2.2 Consented Scheme Comparison Proposed Scheme - Second Floor

2.2 Consented Scheme Comparison Proposed Scheme - FEC, Conference Centre & Waterpark

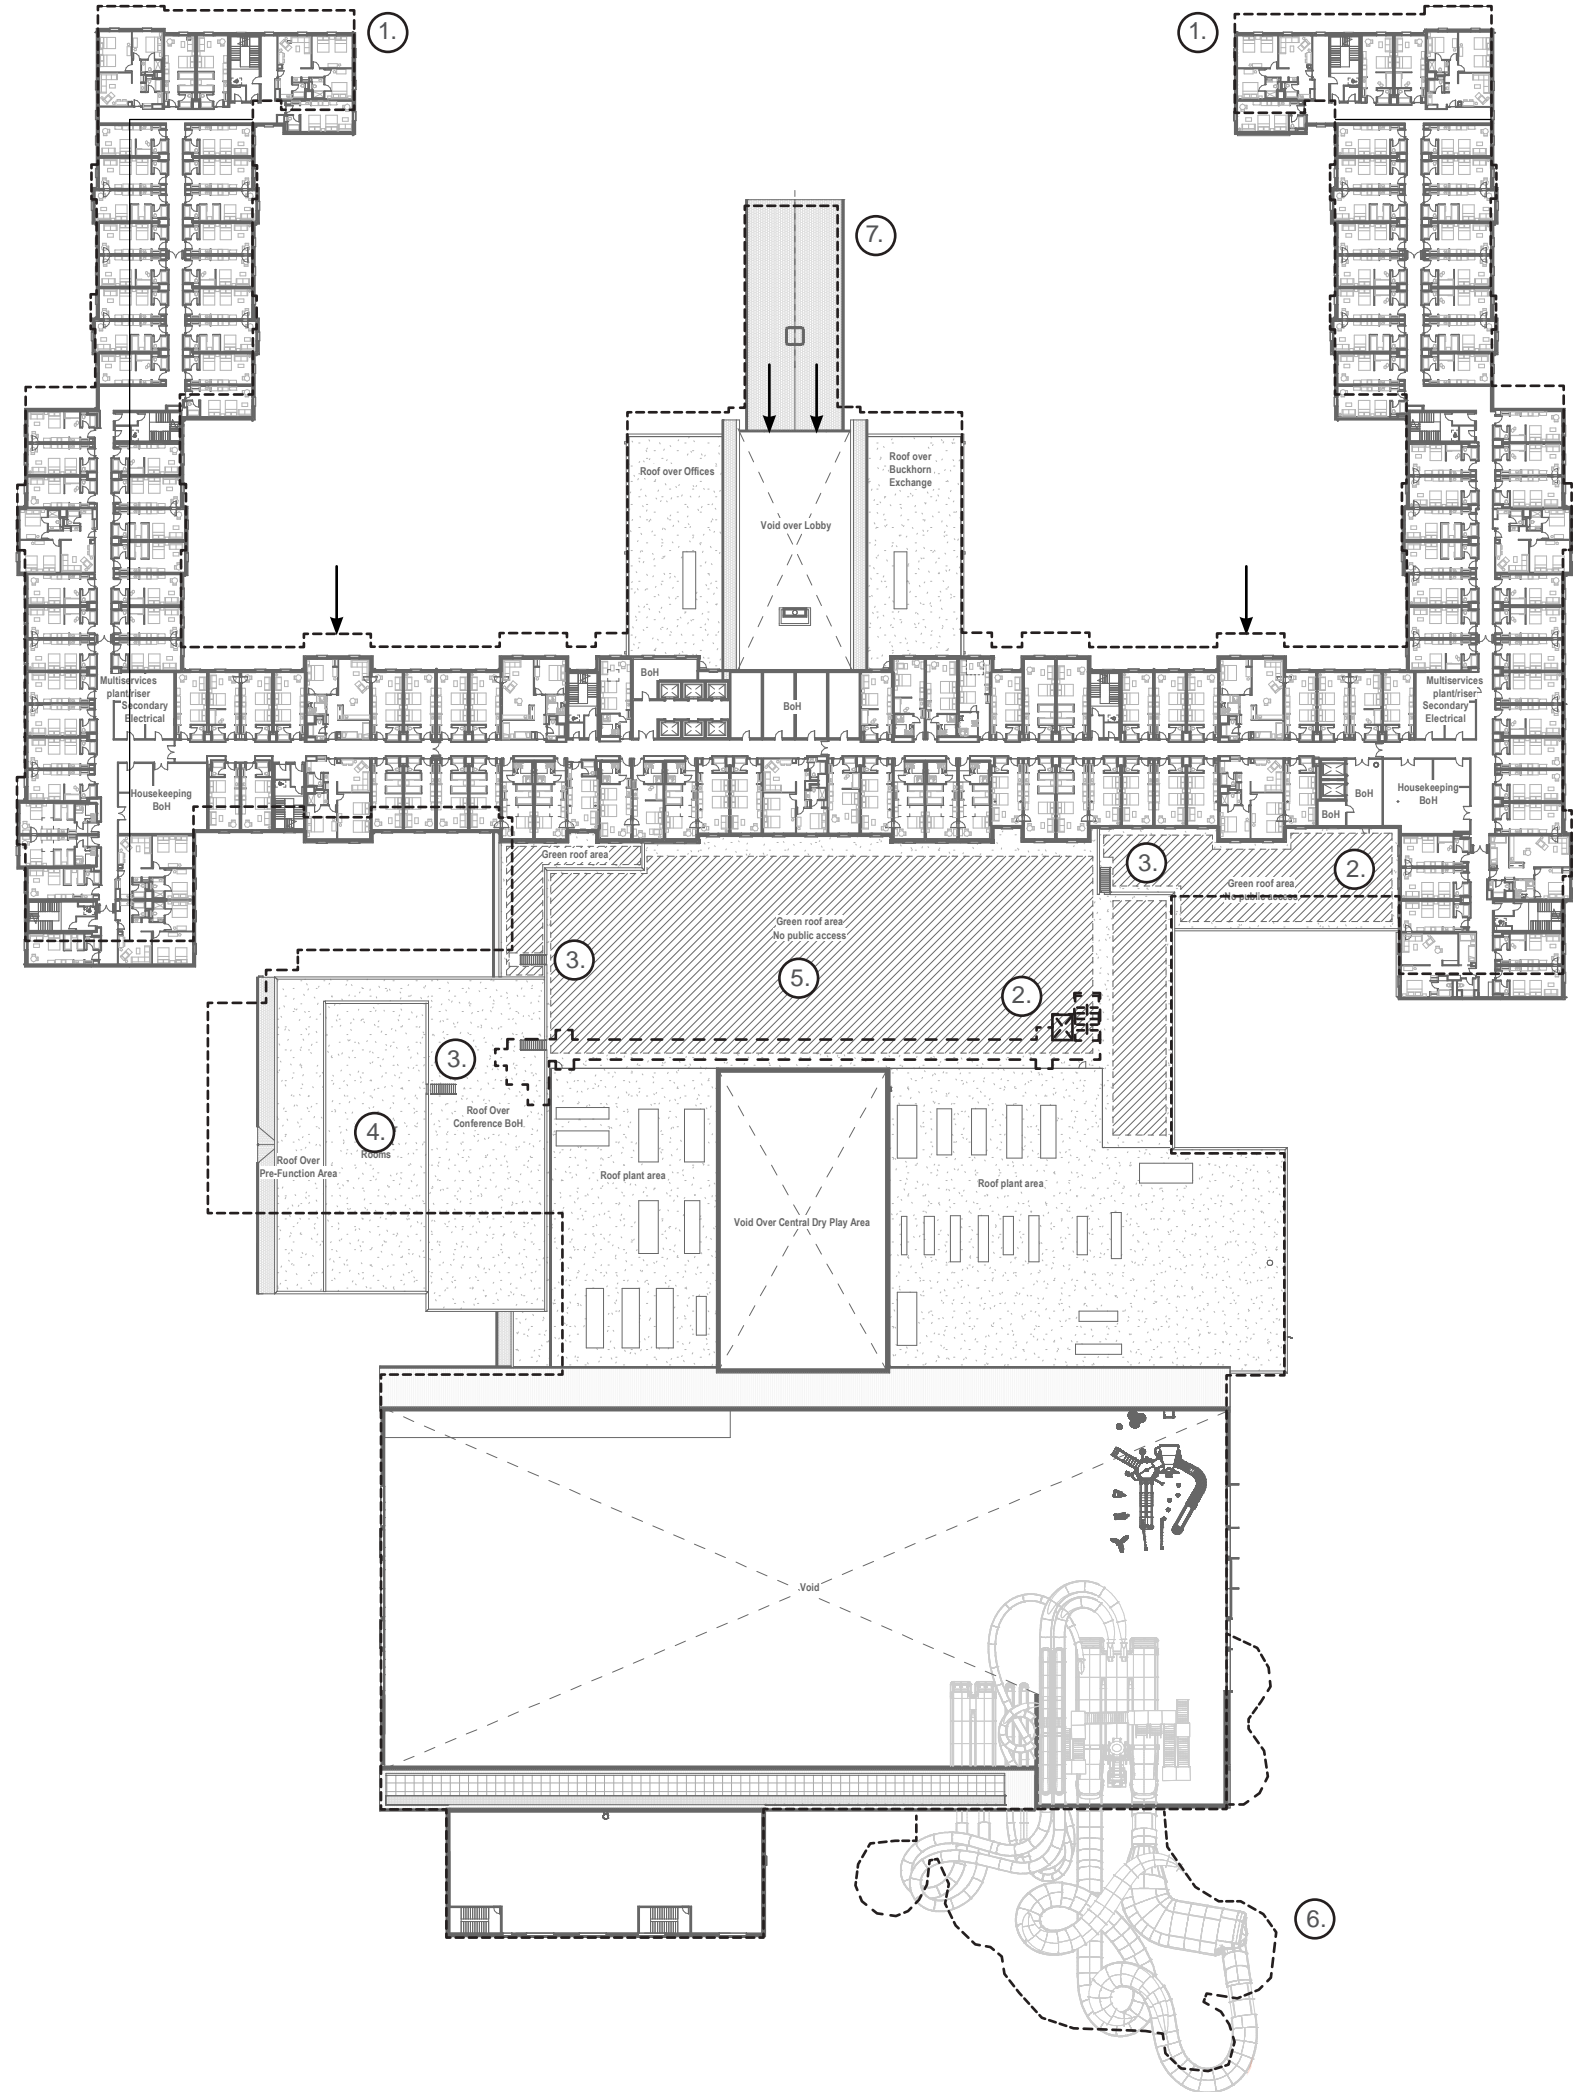
- ① Reduction in the overall size of the FEC resulting in a shift of the guestroom u-shaped tower southwards by approx. 3.6m.
- ② Omission of bridge link above FEC roof for access and maintenance. Service lift and stair extension to roof level omitted with access to roof level now achieved via first floor external door direct onto roof level. Proposed new door onto roof in previously consented window position.

- ③ Access to different roof levels provided via a series of individual external staircases over the flat roof, replacing ladder access as proposed within the original consented scheme.

- ④ Conference centre roof redesign due to redesign of internal layout and facade.
- ⑤ Green roof area reconfigured due to omission of bridge link and shift in building. Overall green roof area maintained as per original consented scheme.

- ⑥ Water slide design updated.
- ⑦ Extension of the Porte cochere as a result of shifting the building southwards 3.6m.

2.2 Consented Scheme Comparison Proposed Scheme - Third Floor

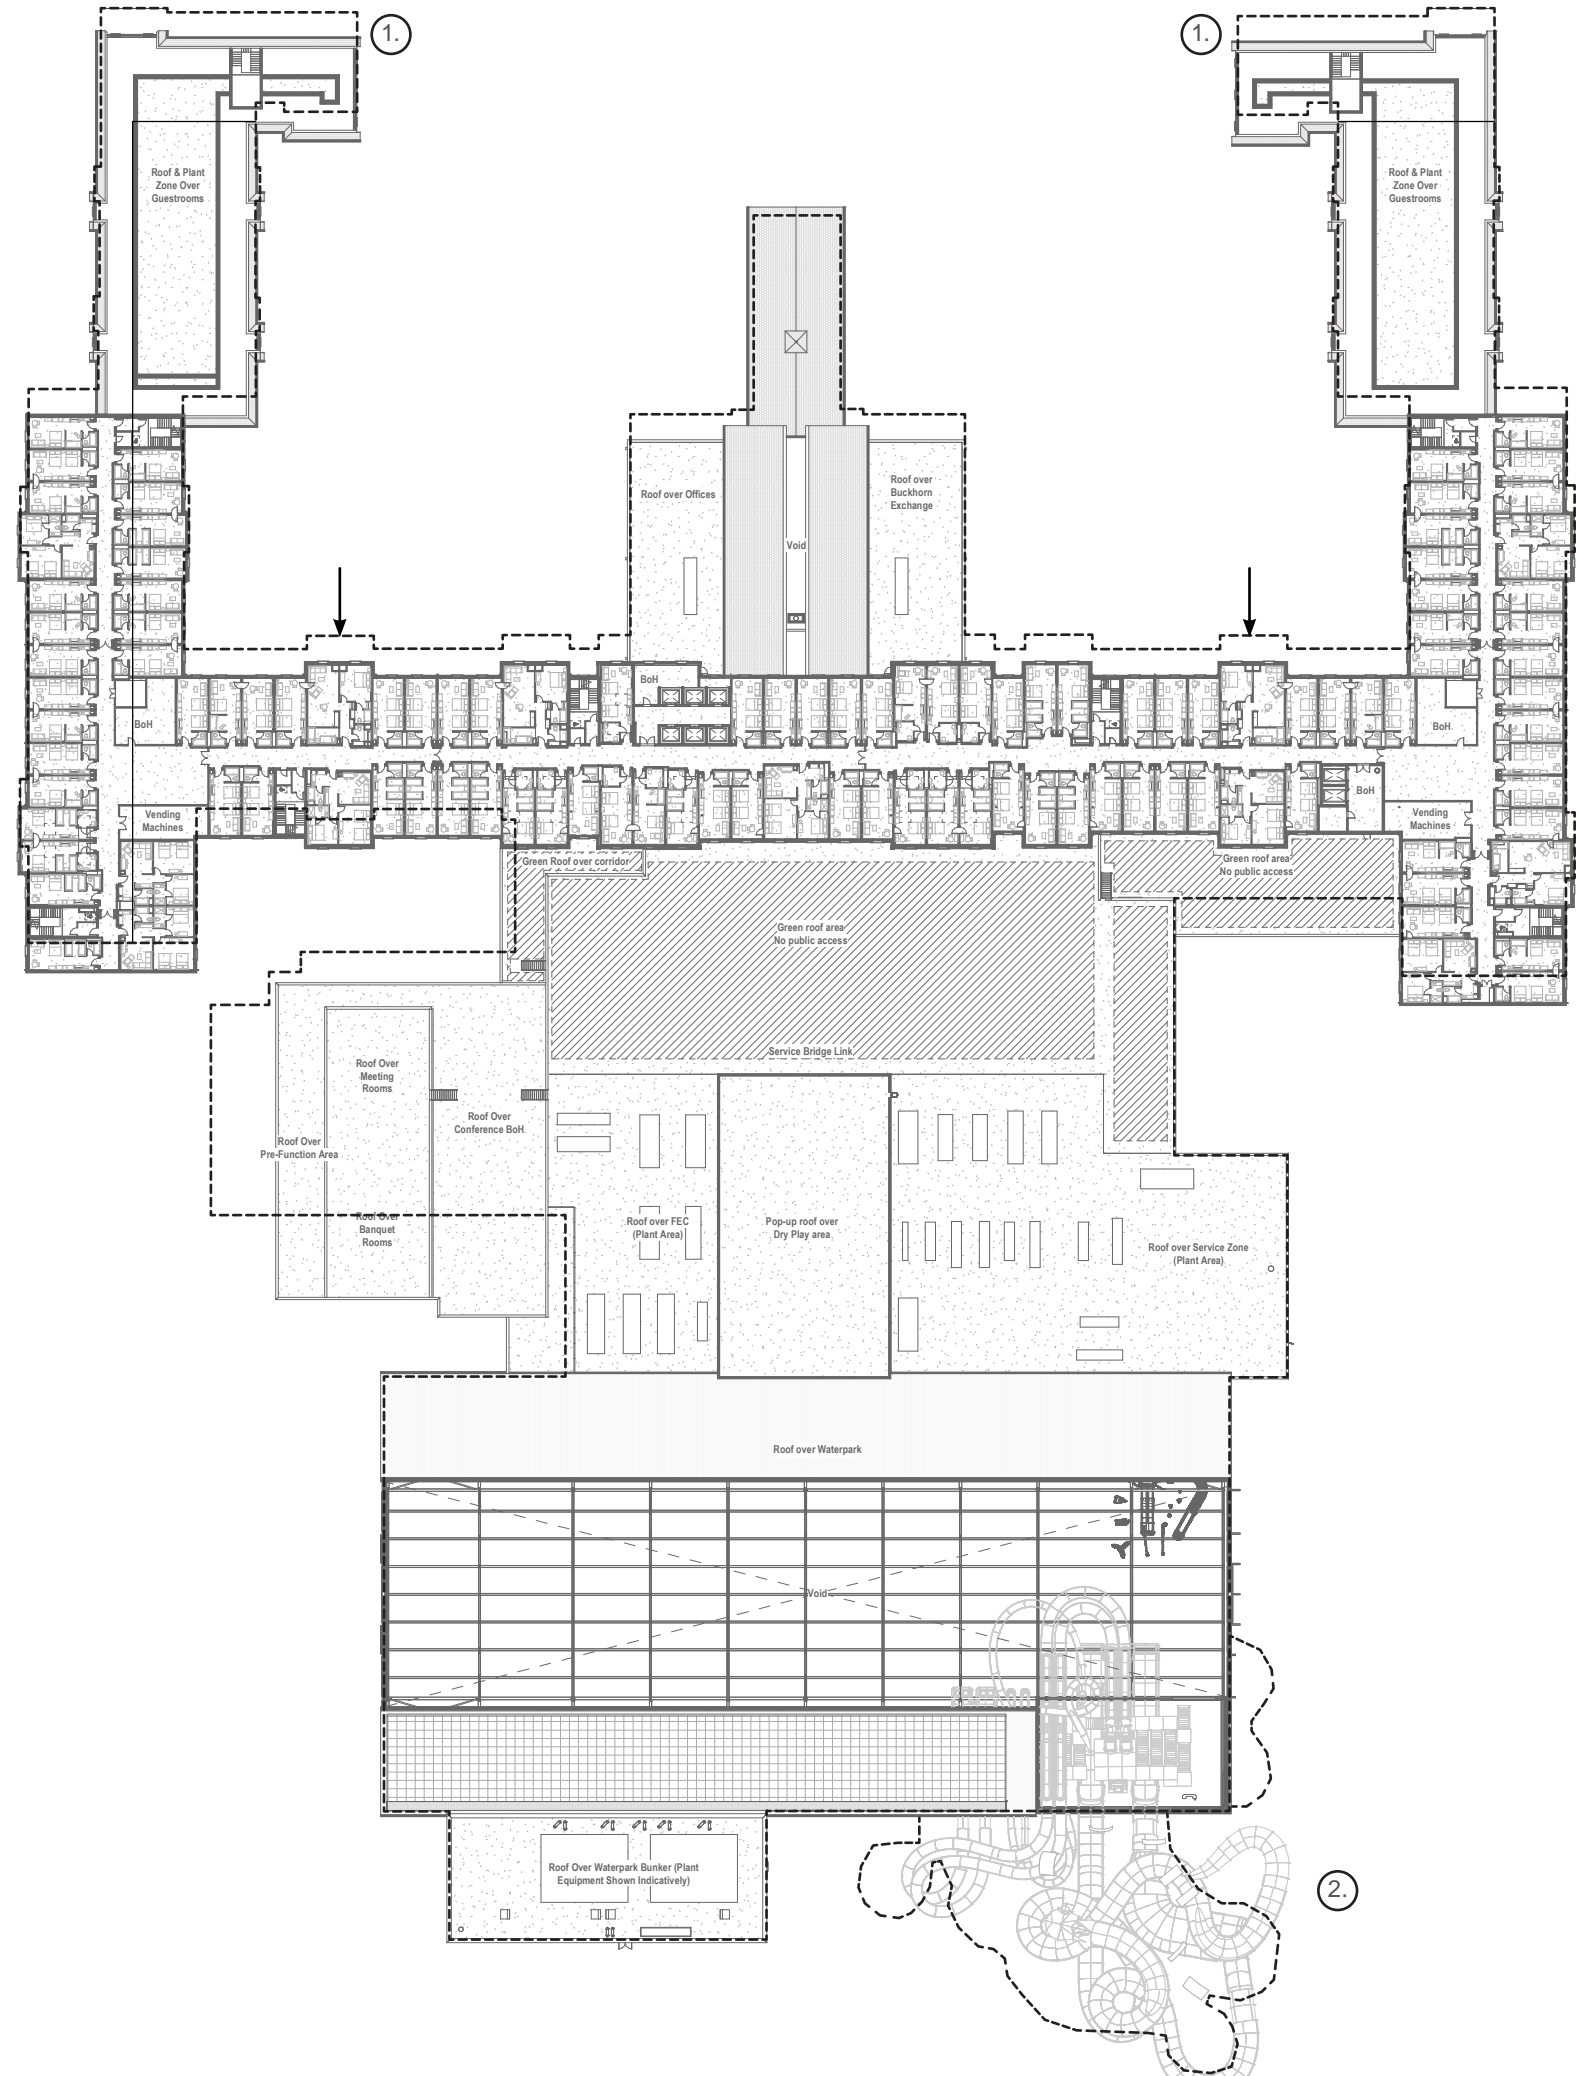
- ① Reduction in the overall size of the FEC resulting in a shift of the guestroom u-shaped tower southwards by approx. 3.6m.
- ② Water slide design updated.

2.2 Consented Scheme Comparison Proposed Scheme - Roof Plan

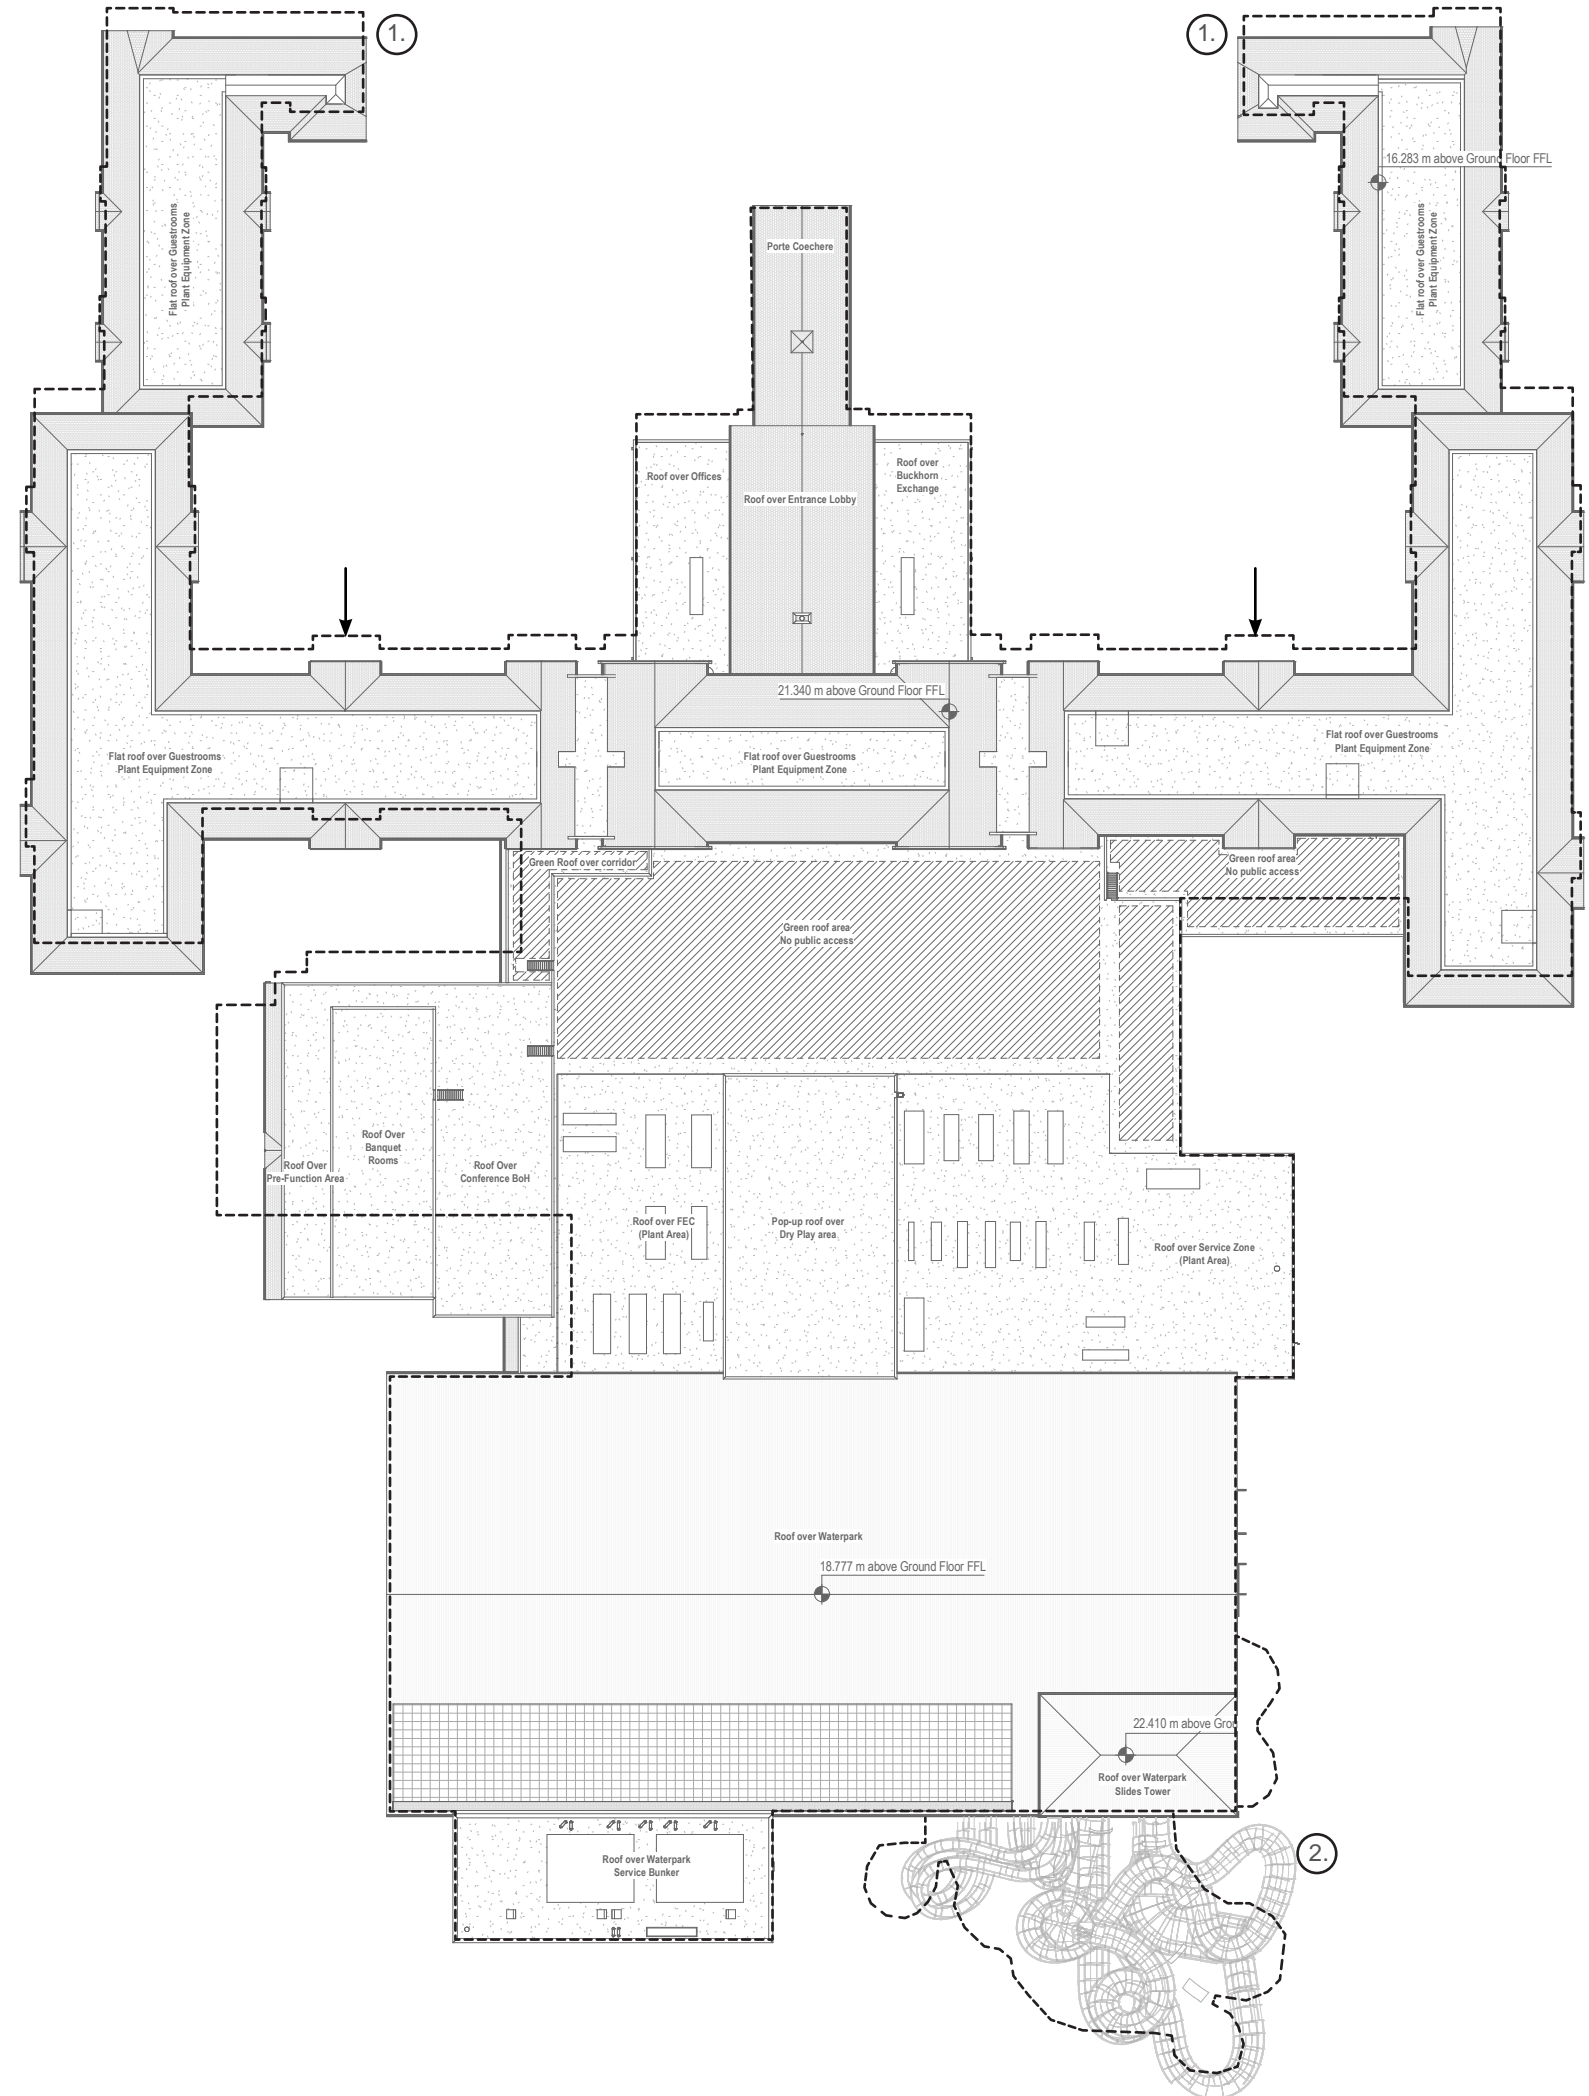
- ① Reduction in the overall size of the FEC resulting in a shift of the guestroom u-shaped tower southwards by approx. 3.6m.
- ② Water slide design updated.
